Access Compliance Report

Public Rights-of-Way

(Curb Ramps)

Intersection ID: 18287	Main Street: BEECHDALE_DR	Cross Street: MCLAUGHLIN_DR	Location: NW
ADA ID: 7D86EA7C0665	Ramp Type: BlendTrans1	Initial Pass/Fail: Fail	Overall Compliance: No
Severity Score: 18.75			
Codes/Mitigation Info/Possible Solution		Field Measurements/Component Compliance

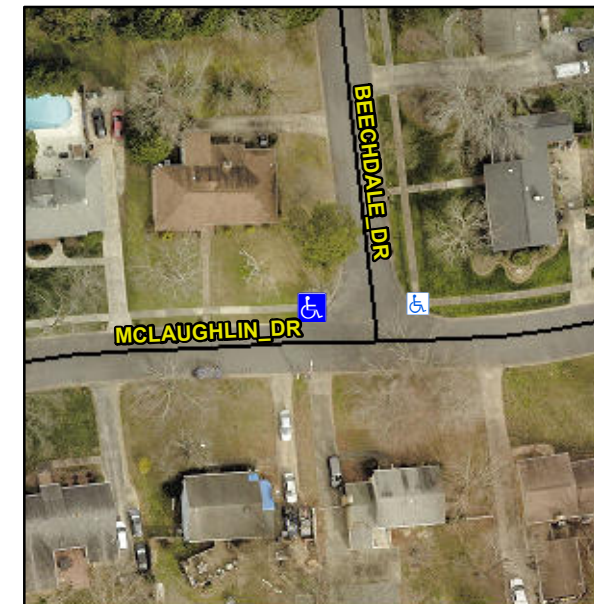
ASP LIP 1.0

Not Found, R304.5.1, R304.5.3

Compliance	Description	Data	Compliance	Description	Data
N/A	Ramp Length (in)	80.0	Yes	BlendTrans Slope (%)	0.3
No	Ramp Width (in)	34.0	No	BlendTrans XSlope (%)	4.6
N/A	Flare Type LT	N/A	N/A	Flare Type RT	N/A
N/A	Flare Slope LT (%)	N/A	N/A	Flare Slope RT (%)	N/A
N/A	Flare Traversable LT?	N/A	N/A	Flare Traversable RT?	N/A
N/A	Landing Length (in)	N/A	N/A	DWS Provided?	N/A
N/A	Landing Width (in)	N/A	N/A	DWS Contrast?	N/A
N/A	Landing Slope (%)	N/A	N/A	DWS Length (in)	N/A
N/A	Landing X Slope (%)	N/A	N/A	DWS Full Width?	N/A
N/A	Landing Curb? (Y/N)	N/A	N/A	DWS Offset (in)	N/A
N/A	Shared Landing?	N/A			
N/A	Gutter Ponding?	N/A	N/A	Gutter Slope (%)	N/A
N/A	Gutter Lip Ht (in)	N/A	N/A	Gutter X Slope (%)	N/A
N/A	Painted X Walk1?	No	N/A	Painted X Walk2?	No
	X Walk 1 Direction	To S		X Walk 2 Direction	To E
	X Walk 1 Width (in)	N/A		X Walk 2 Width (in)	N/A
	X Walk 1 Slope (%)	2.4		X Walk 2 Slope (%)	6.8
	X Walk 1 X Slope (%)	2.5		X Walk 2 X Slope (%)	3.6

N/A	Ramp inside XWalk1?	N/A	N/A	Ramp inside XWalk2?	N/A
	Road Slope (%)	2.2		Clear Space?	N/A
	Road X Slope (%)	5.3	N/A	Clear Space to XWalk (in)	N/A
N/A	Any Obstructions?	N/A	N/A	Storm Grate/Utility Hazard?	N/A
	Obstruction Type			Storm Grate/Utility Type	
		N/A			N/A
			Yes	Surface Condition? (G/P)	Good
			No	Curb Slope (%)	11.8

Remove & Replace Curb Ramp With Two New Directional Ramps or Equivalent.
